California Endangered Species Act Amended Incidental Take Permit No. 2081-2023-029-04 BLACKWELL'S CORNER CAPM PROJECT (PROJECT) CALTRANS EA 06-0Y130

II. Amended ITP⁴ Background:

ITP No. 2081-2023-029-04 was originally issued on November 20, 2023. On July 17, 2024, CDFW received a request from Permittee for a major amendment (Amendment No. 1) to the original ITP and the corresponding fee payment. Permittee requested to amend the ITP to: (1) extend the permit expiration date by 36 months to May 30, 2028, to allow enough time for

On October 3, 2024, CDFW received a request from Permittee for a second major amendment (Amendment No. 2) to the ITP, and on October 17, 2024, CDFW received the corresponding fee payment. Permittee requested to amend the ITP, as previously amended, to add the fully protected and state endangered blunt-nosed leopard lizard (BNLL) as a species covered by the ITP and to add six staging areas outside of the state highway right-of-way to the Project area. The Permittee requested to add BNLL as a Covered Species to the ITP after the species was observed within the Project area during pre-activity surveys in September 2024. CDFW also initiated several modificatio

FIGURE 2 Amended Project Impacts Map Book

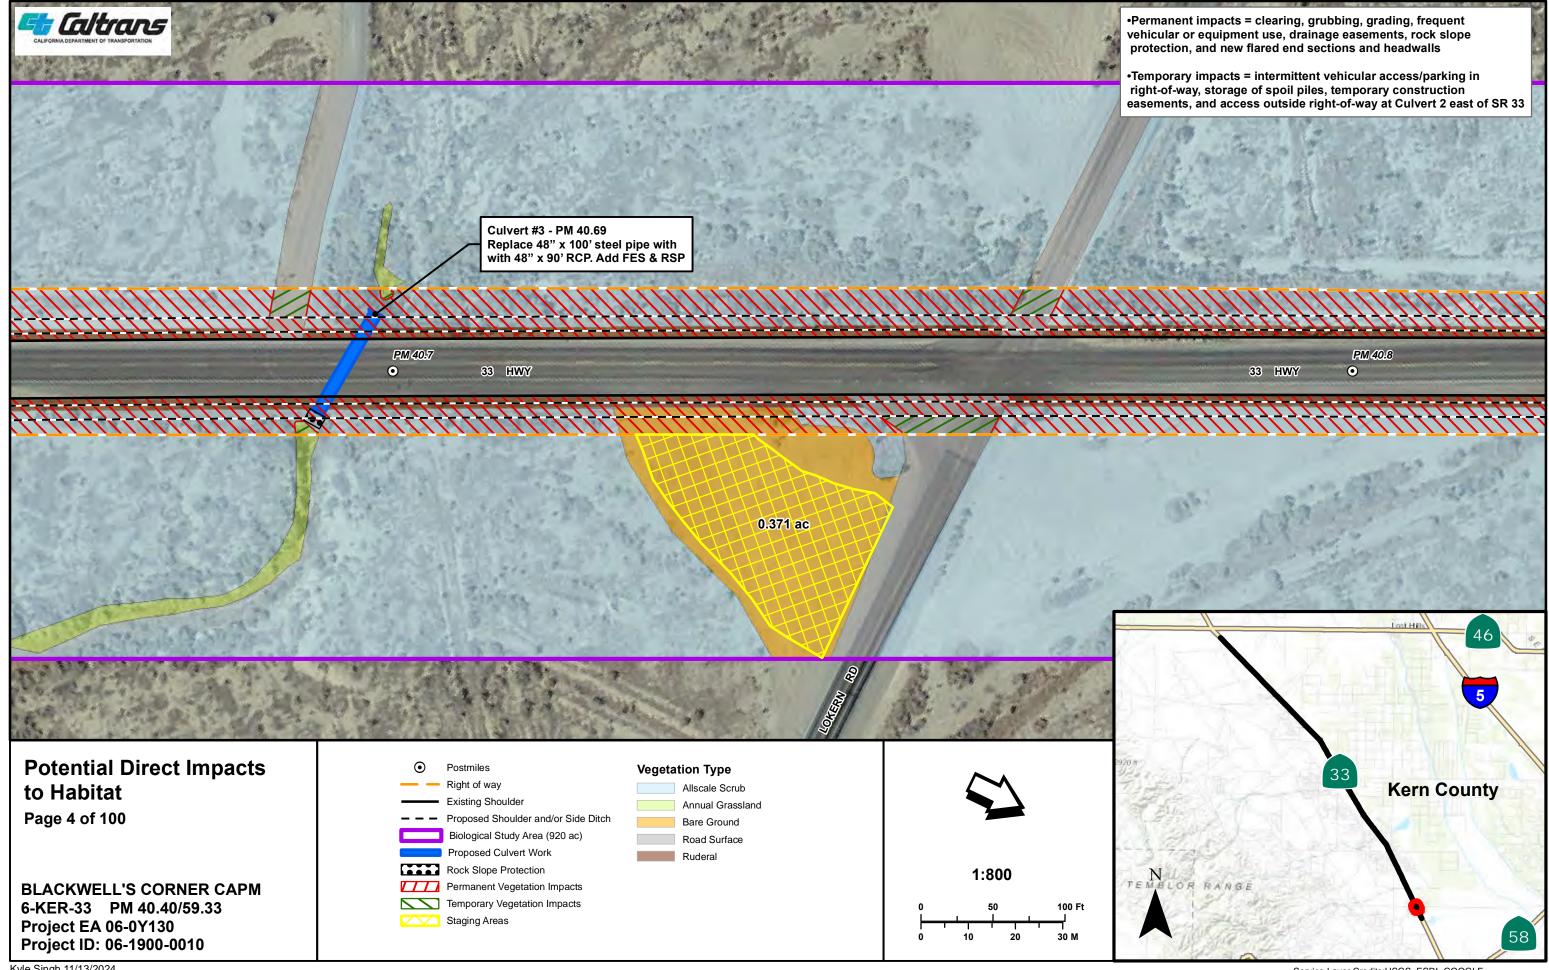
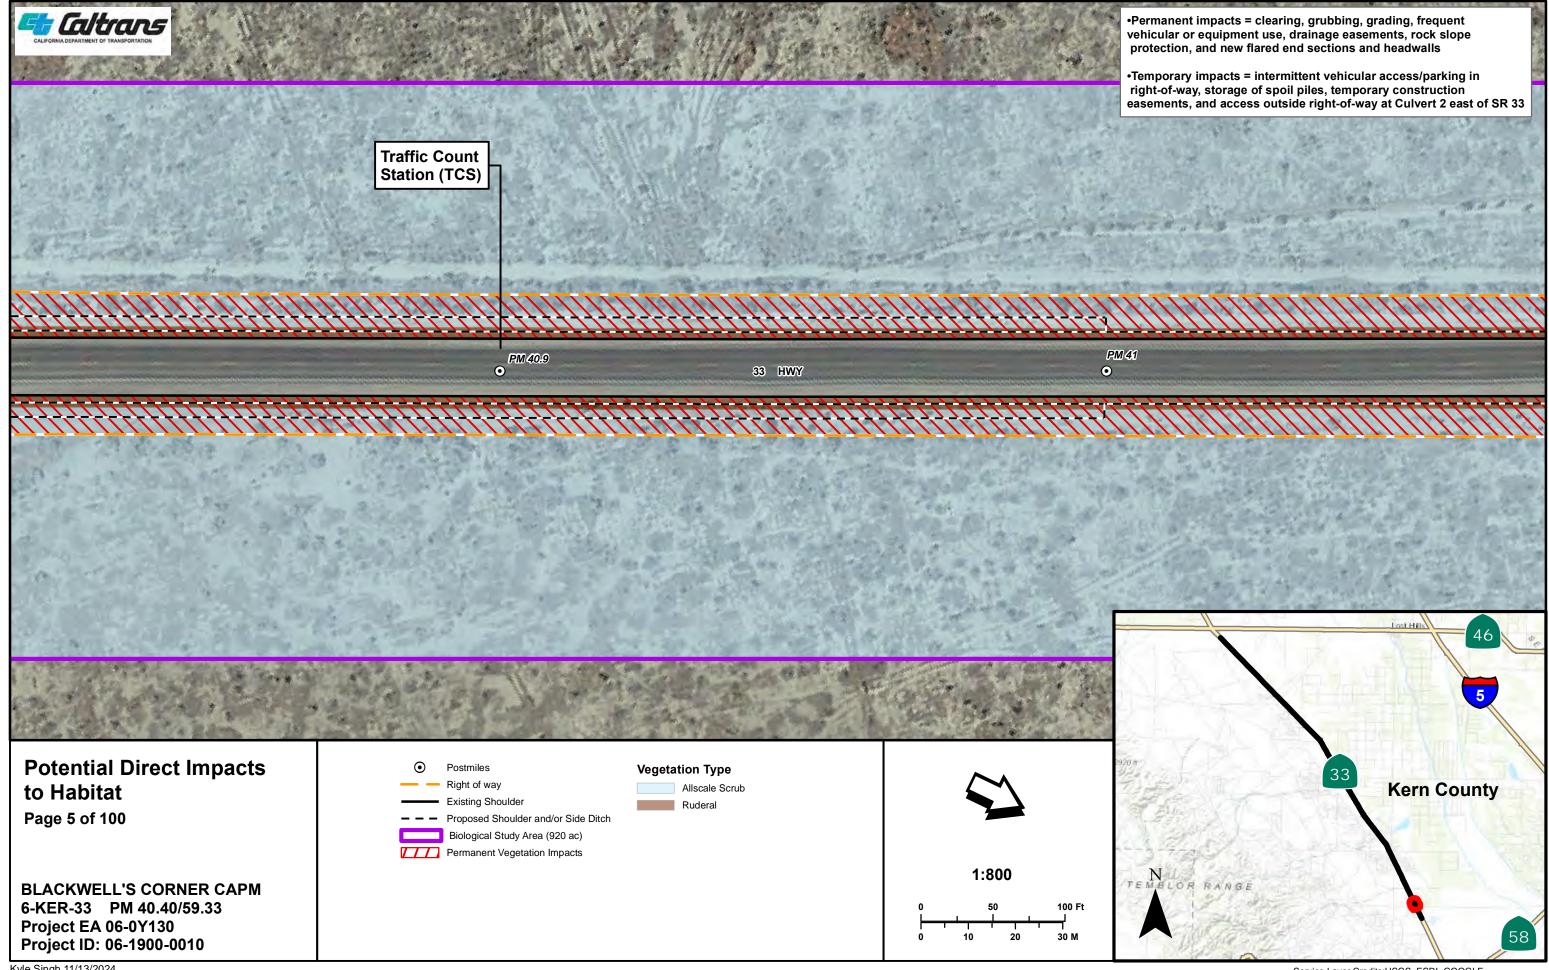
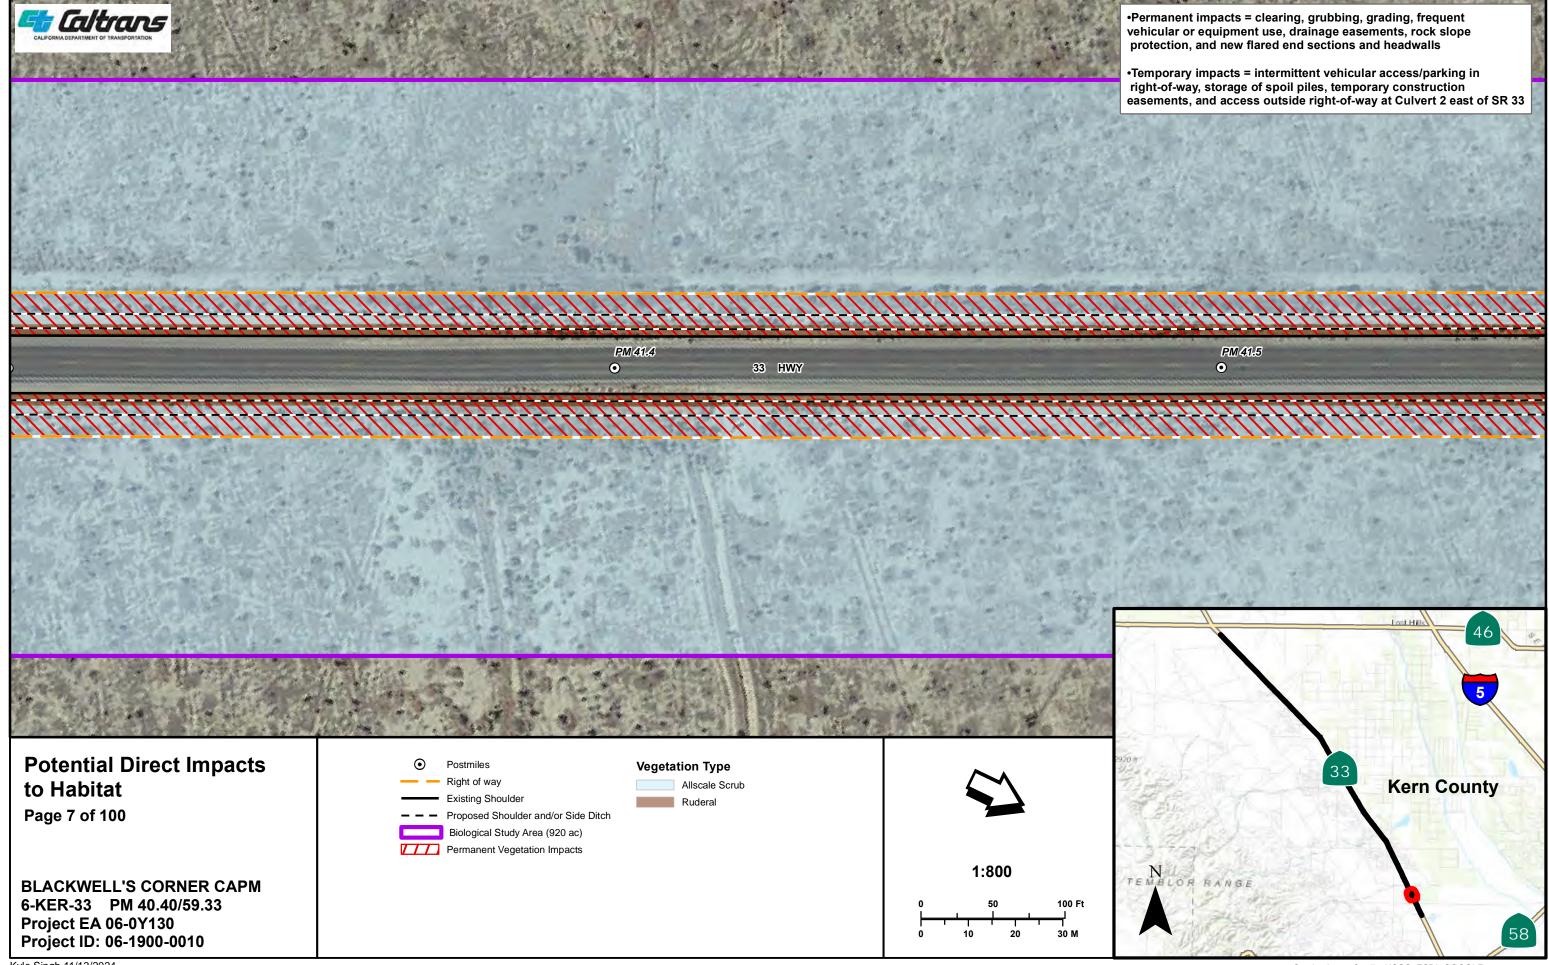
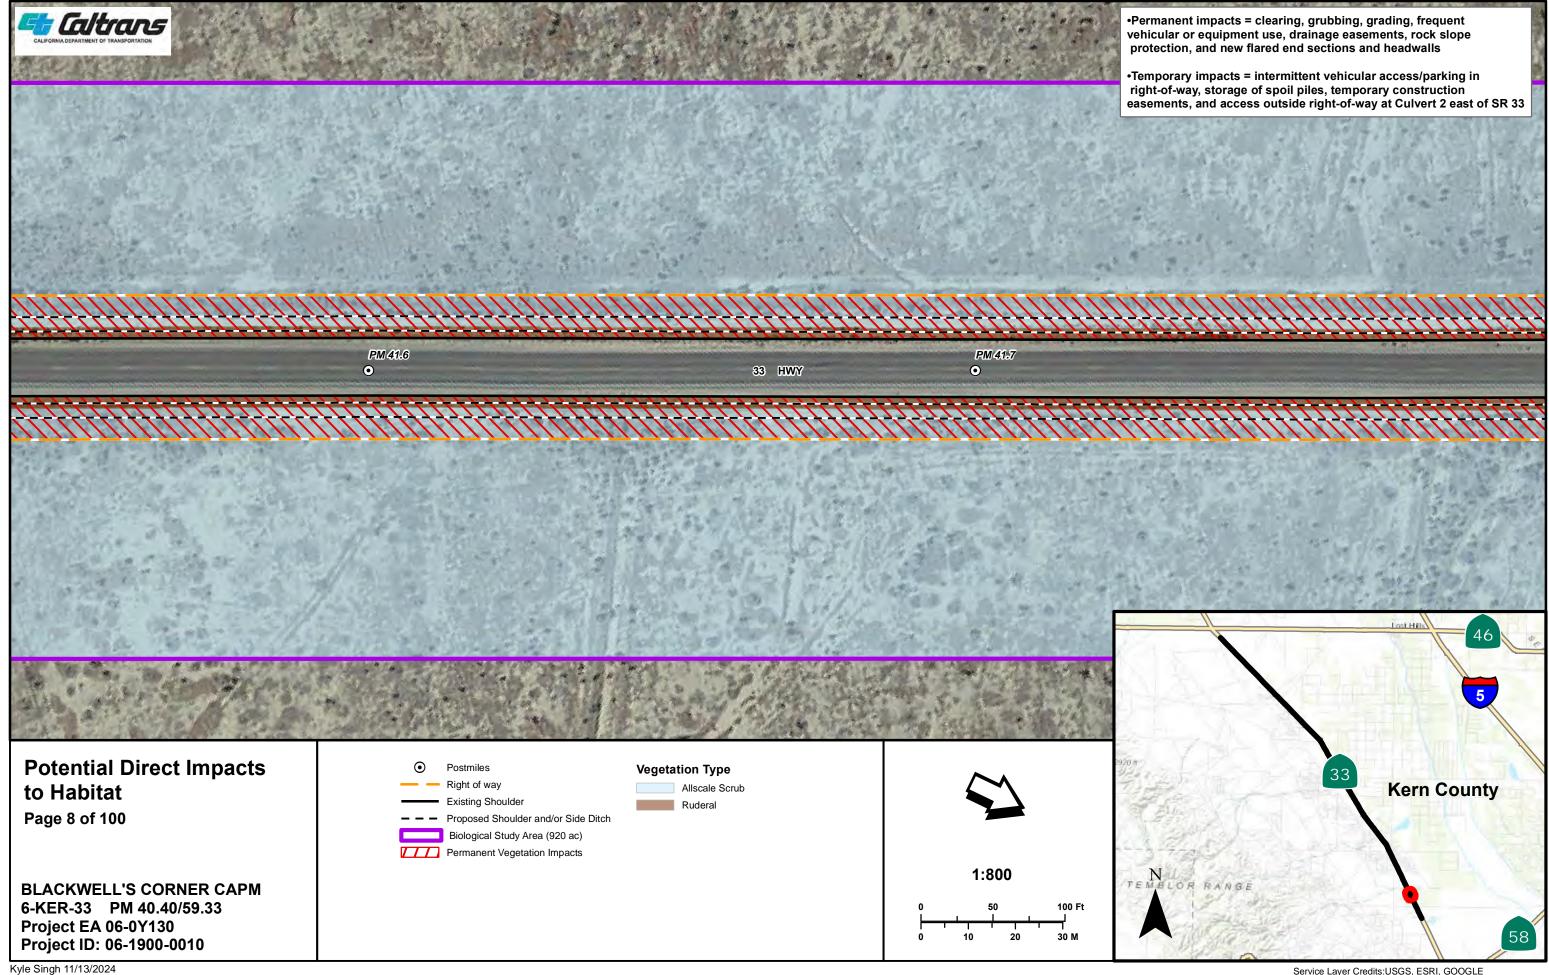
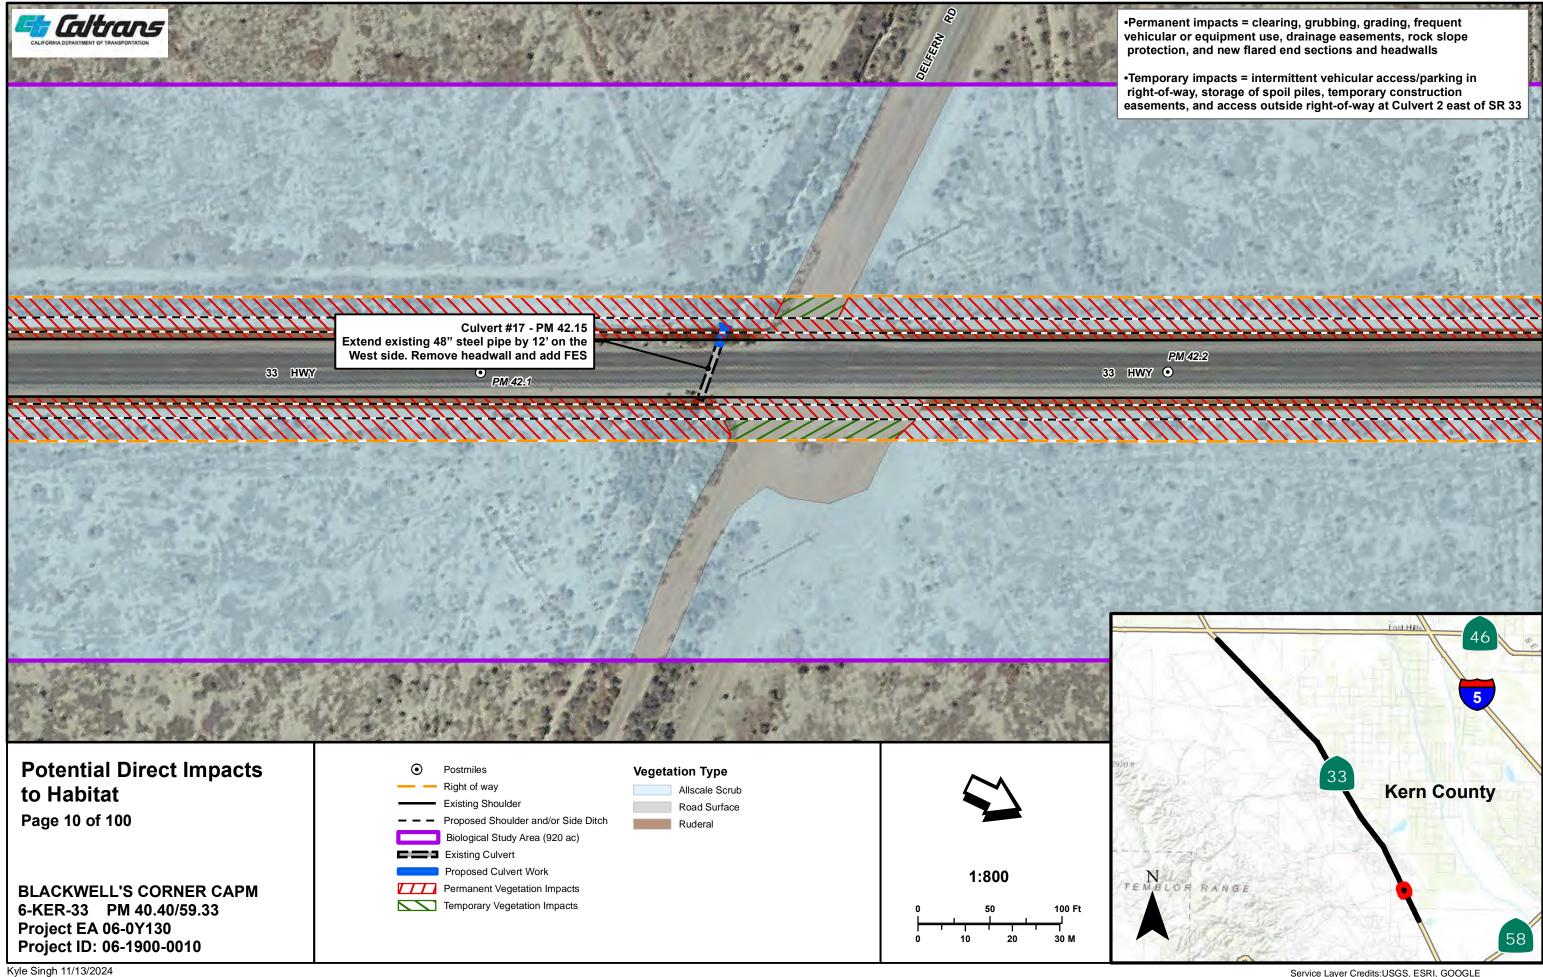
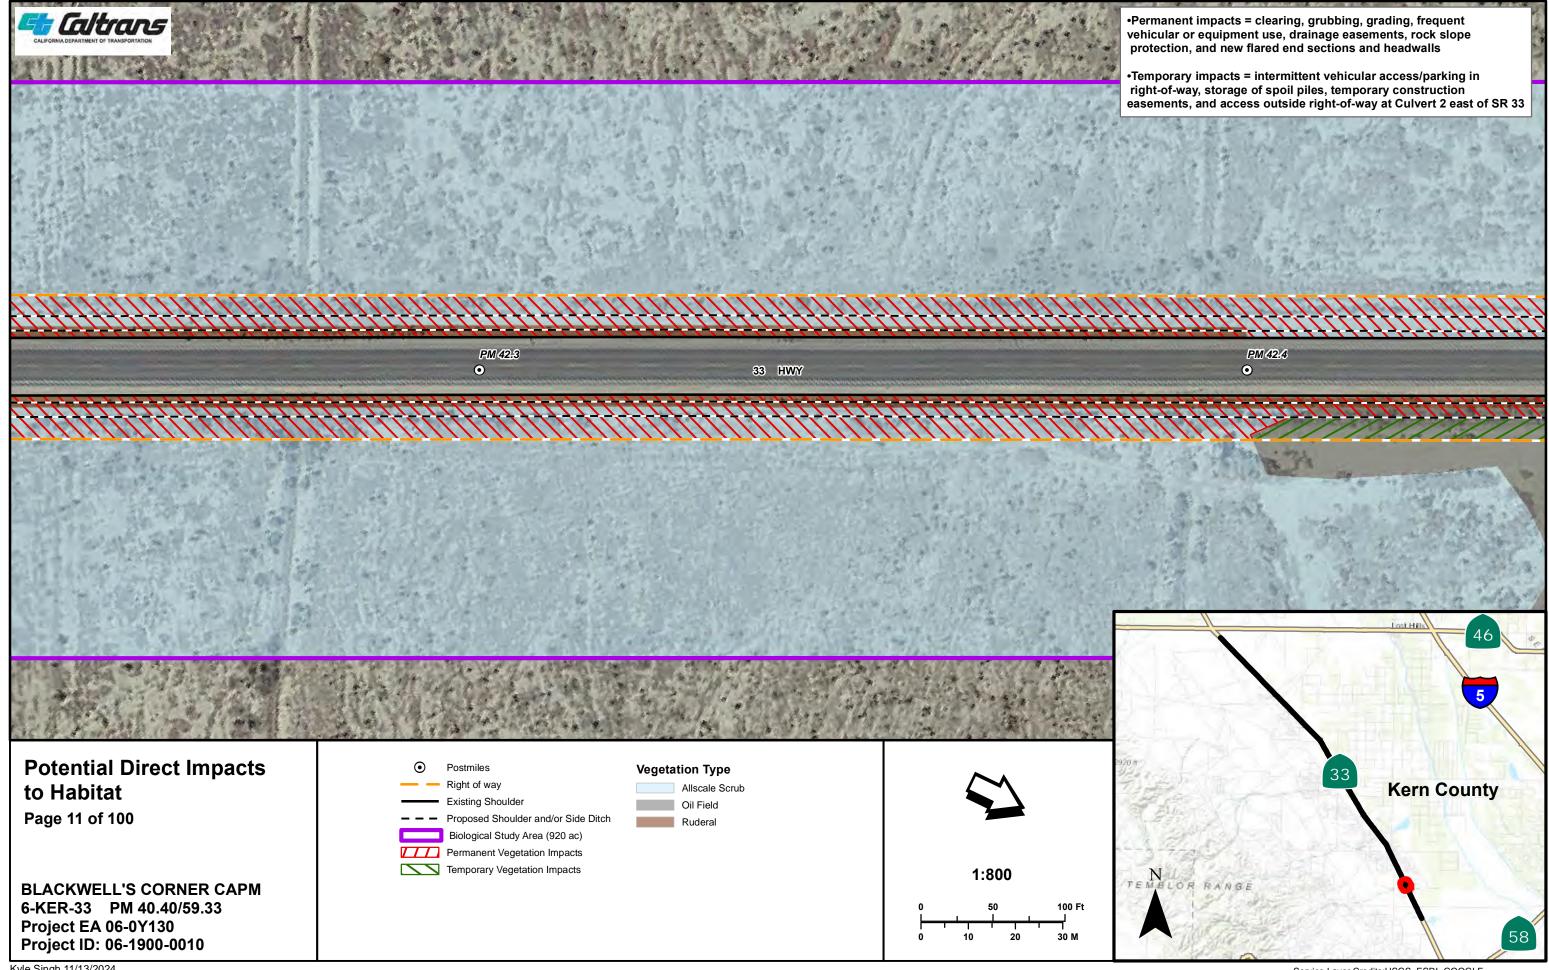
The Project is expected to result in the permanent loss of up to 55.11 acres and in temporary disturbance of up to approximately 10.242 19.36 acres of suitable habitat for the Covered Species (allscale scrub, annual grassland, ruderal, oil field, bare ground, and fallow field habitat types) (Figure 2).
